# CITY OF ALBUQUERQUE

**Re:** East Gateway Dwelling Units  
**13400 Wenonah Dr NE**  
**Traffic Circulation Layout**  
Architect's Stamp 07-13-16 (L22D033A1)

Based upon the information provided in your submittal received 08-24-16, the above referenced plan cannot be approved for Building Permit until the following comments are addressed:

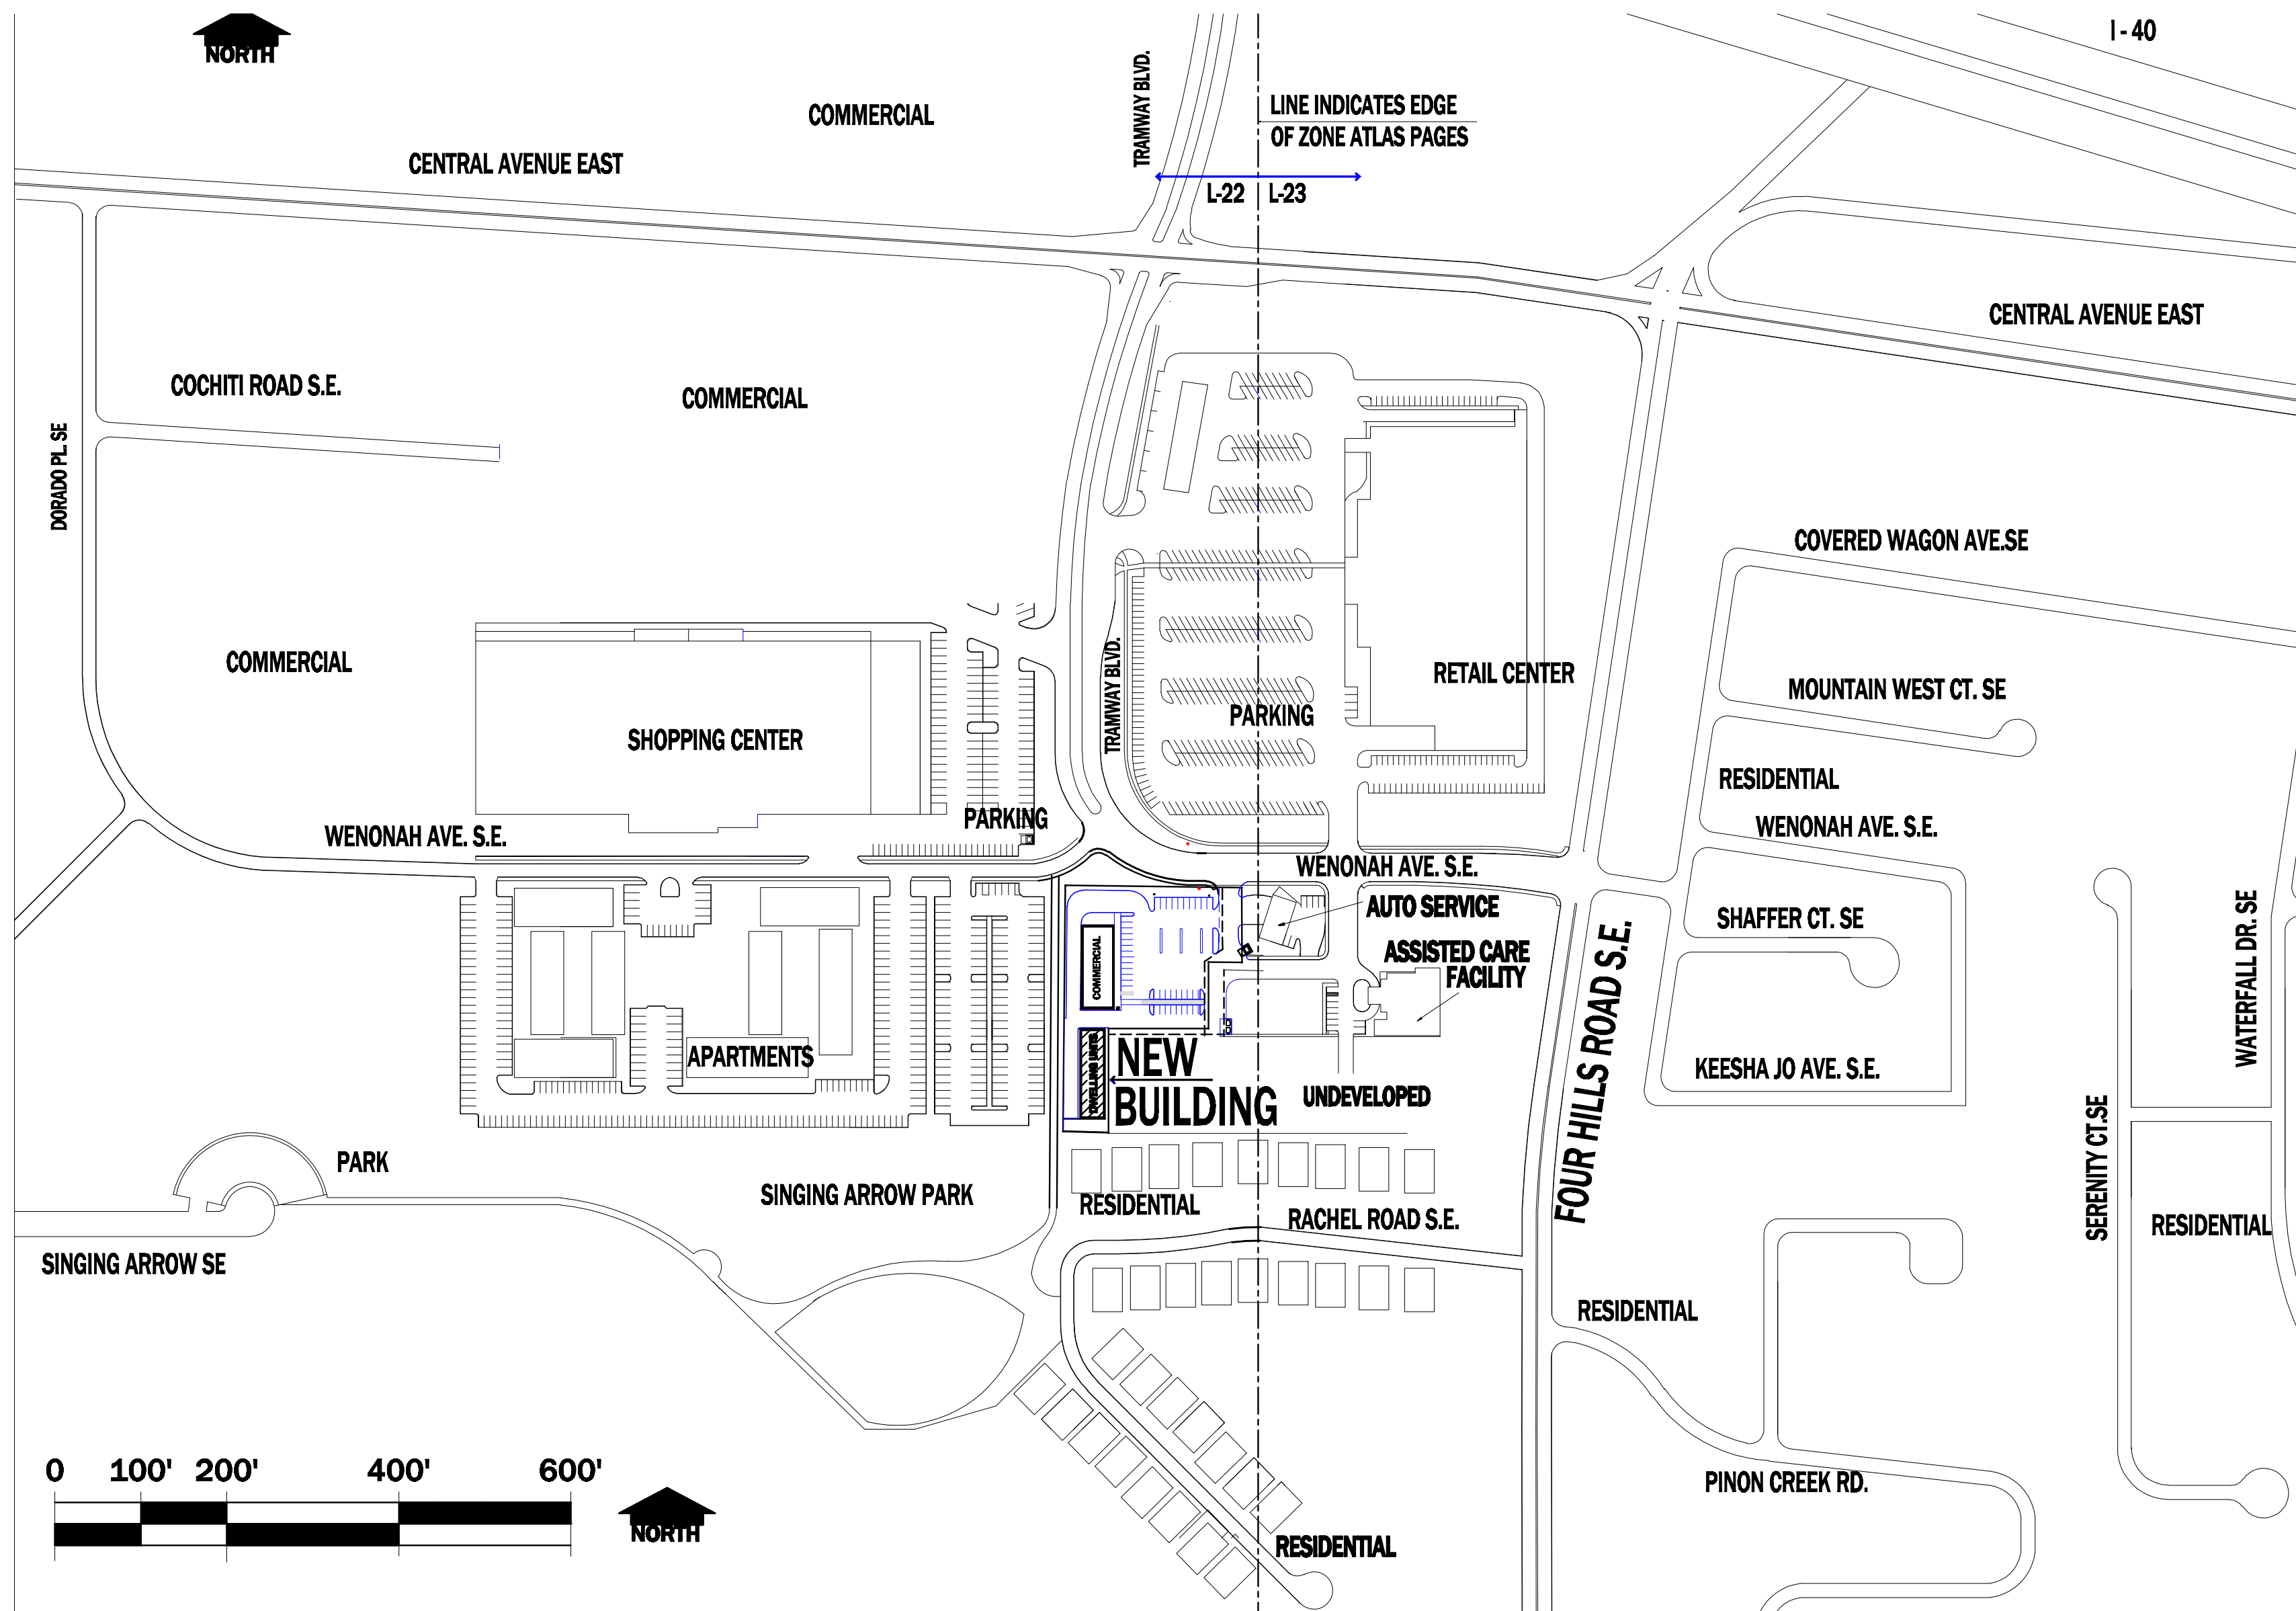
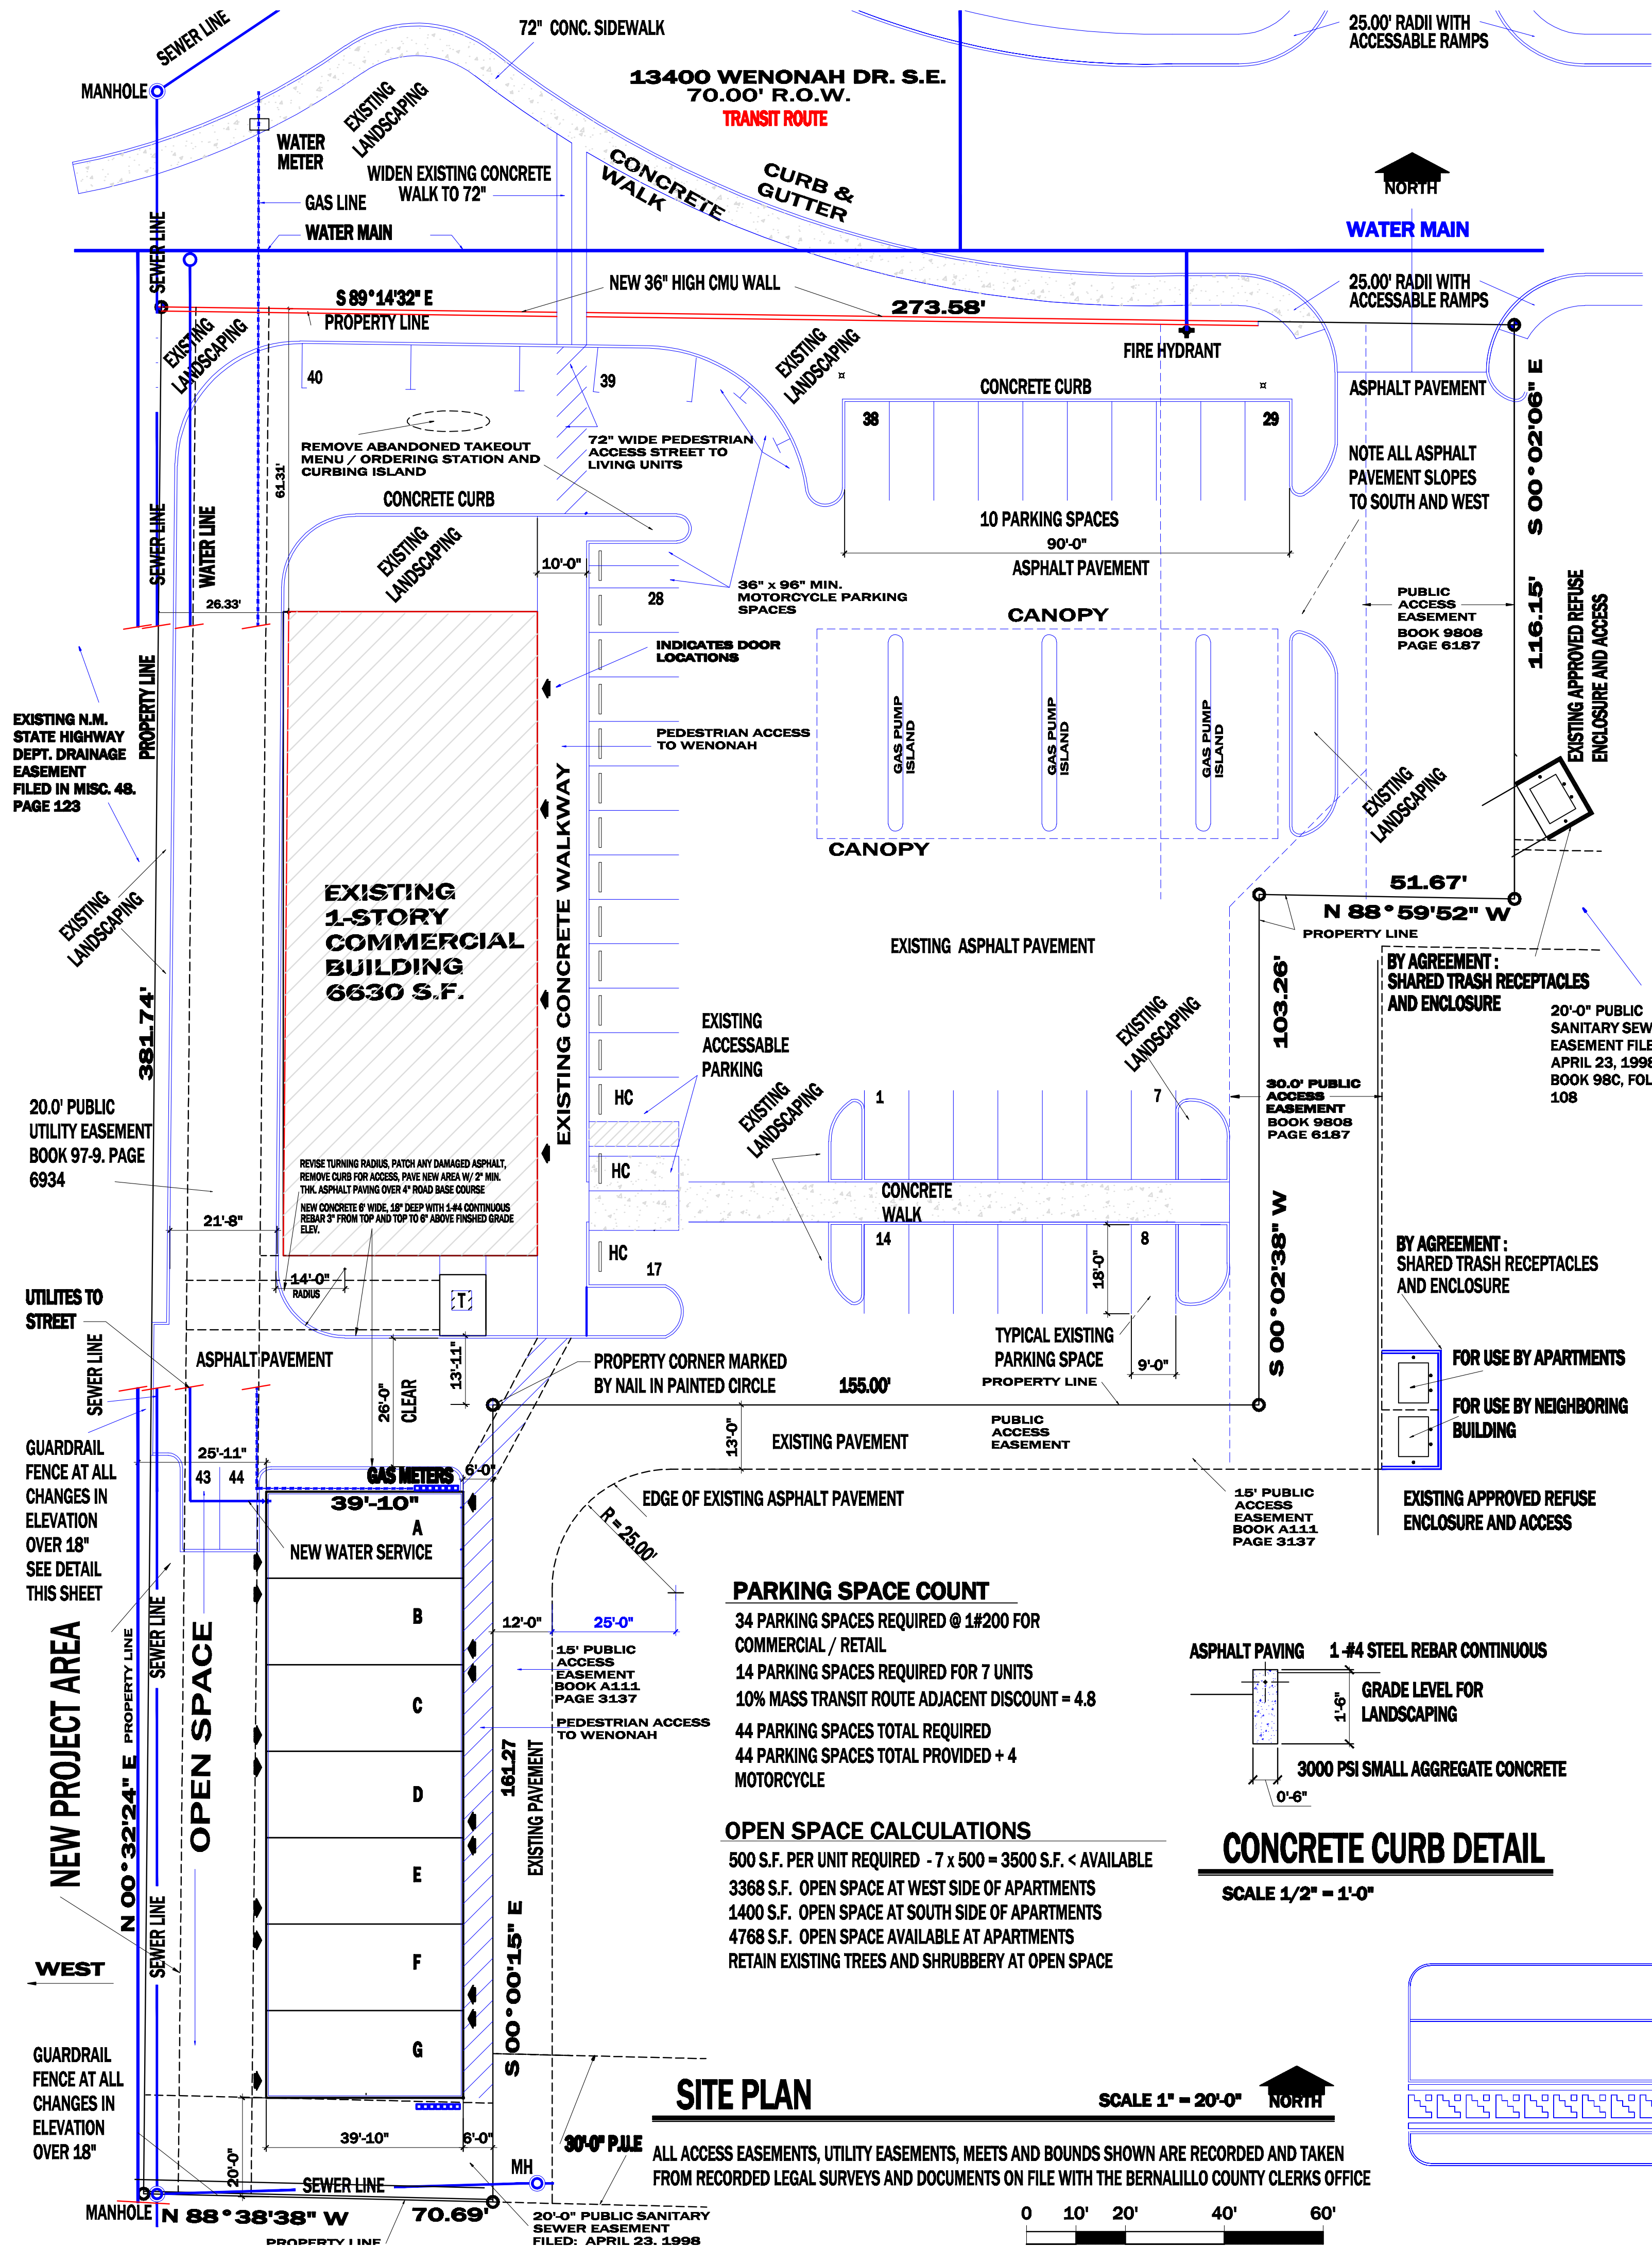
1. The number of parking spaces provided does not match the total required. Please provide number of ADA, motorcycle and bicycle parking required and provided for this site.

2. Identify the right of way width, medians, curb cuts, and street widths on Wenonah Ave.
3. Please list the width and length for all existing and proposed parking spaces. Some dimensions are not shown.

4. Motorcycle parking spaces must be visible to the entrance of the building.
5. A bicycle rack must be provided for the dwelling units.
6. The handicap accessible spaces must be a minimum of 8.5 ft. in width.

7. The handicap accessible spaces must include an access aisle. Van accessible aisles should be 8ft wide; all others should be 5ft wide.
8. The ADA accessible parking sign must have the required language per 66-7-352.4C NMSA 1978 **"Violators Are Subject to a Fine and/or Towing."** Please call out detail and location of HC signs.

9. The ADA access aisles shall have the words **"NO PARKING"** in capital letters, each of which shall be at least one foot high and at least two inches wide, placed at the rear of the parking space so as to be close to where an adjacent vehicle's rear tire would be placed. (66-1-4.1.B NMSA 1978)

10. Provide detail including dimensions for pedestrian and vehicular access to the dwelling units.
11. A 5 ft. keyway is required for dead-end parking aisles.

12. Provide a min 6" or max 8" high concrete barrier curb or other acceptable barrier between landscaping and parking areas and/or drive aisles. Please call out detail and location of barrier curb.

13. Dimension the drive aisle on the north side of the existing building from the perpendicular parking spaces to the concrete curb.
14. All drive aisle less than 24' may only be used at one-way access.

15. One-way vehicular paths require pavement directional signage and a posted **"Do Not Enter"** sign at the point of egress. Please show detail and location of posted signs.

16. Show the clear sight triangle and add the following note to the plan:  
"Landscaping and signage will not interfere with clear sight requirements. Therefore, signs, walls, trees, and shrubbery between 3 and 8 feet tall (as measured from the gutter pan) will not be acceptable in the clear sight triangle.

17. Please specify the City Standard Drawing Number when applicable.
18. Please include a copy of your shared access agreement with the adjacent property owner.

19. Add a note stating "All broken or cracked sidewalk must be replaced with sidewalk and curb & gutter." A build note must be provided referring to the appropriate City Standard drawing.
